**NO: 11-07-98 Rev. A**

**SUBJECT: Outer Exhaust Manifold Studs Breaking**

**DATE: Dec. 11, 1998**

**FIGURE 1**

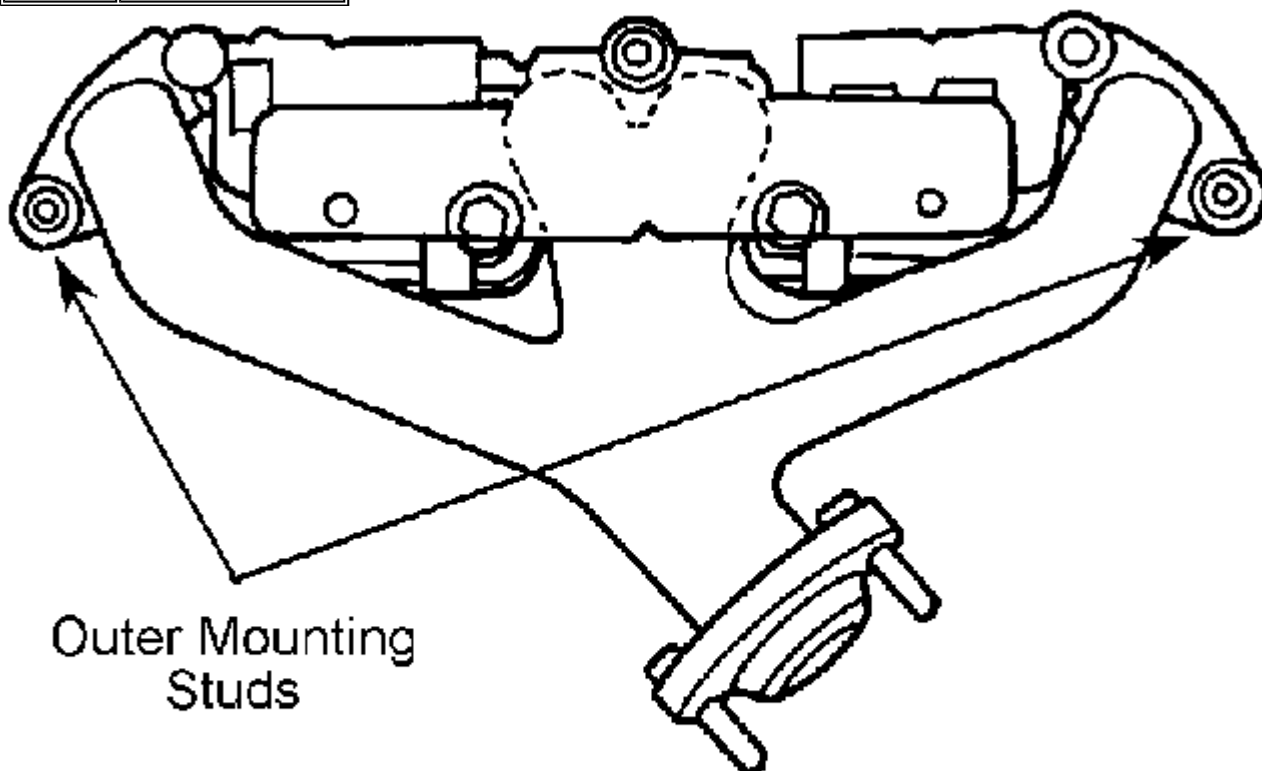
The outer exhaust manifold studs may fatigue and break ([Figure 1](#)).

**FIGURE 2**

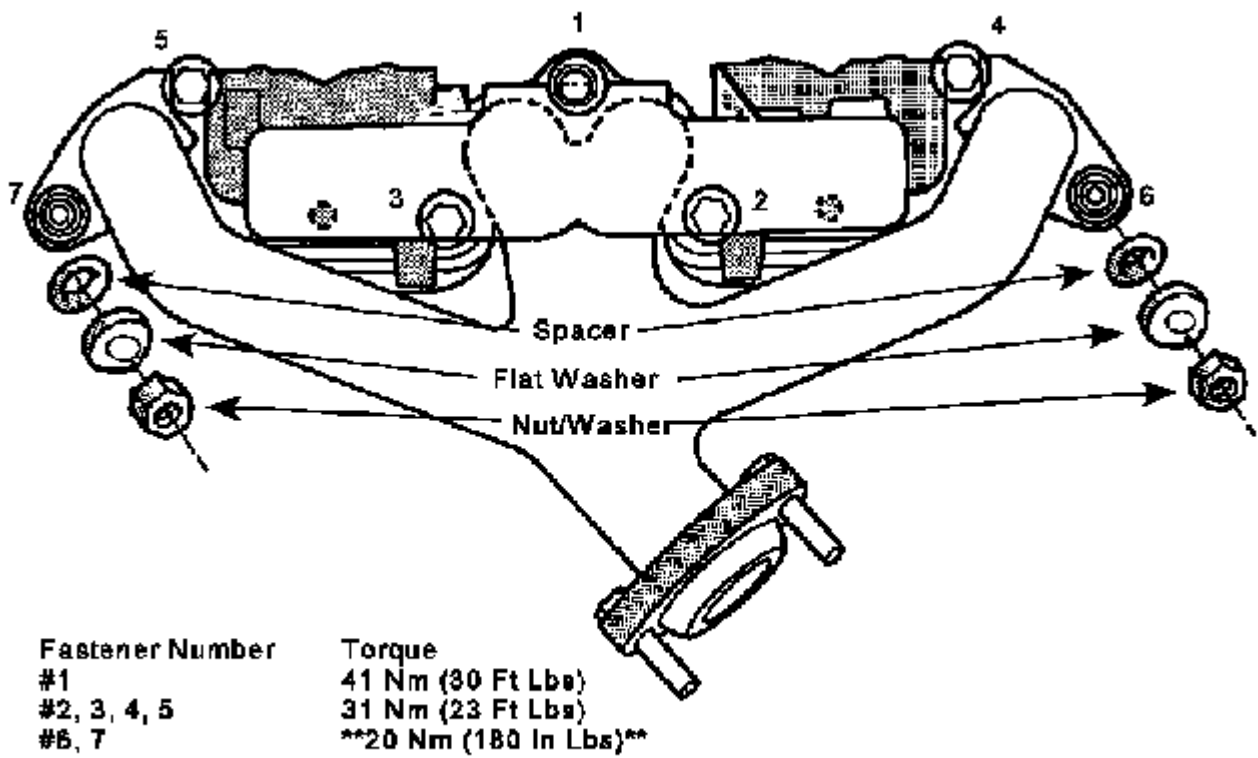
1. Remove the intake/exhaust manifold per service manual procedures to gain access to the broken stud(s).
2. Remove the outer studs from the cylinder head. Use a stud removal tool if possible or drill the broken stud from the head.
3. Install two new outer studs p/n 06036193AA into the cylinder block. **\*\*Torque the studs to 14 Nm (126 in. lbs.)\*\***.
4. Clean any carbon deposits or debris from the exhaust manifold.
5. Reinstall the exhaust manifold. **\*\*Use only the new parts listed above to attach the outer ends ([Figure 2](#)).**
6. Torque the bolts in the order and specification as listed in [Figure 2](#).

**\*\*NOTE: THE TORQUE SPECIFICATION FOR THE OUTER EXHAUST MANIFOLD STUDS HAVE BEEN REDUCED TO 20 NM (180 IN. LBS.)\*\*.**
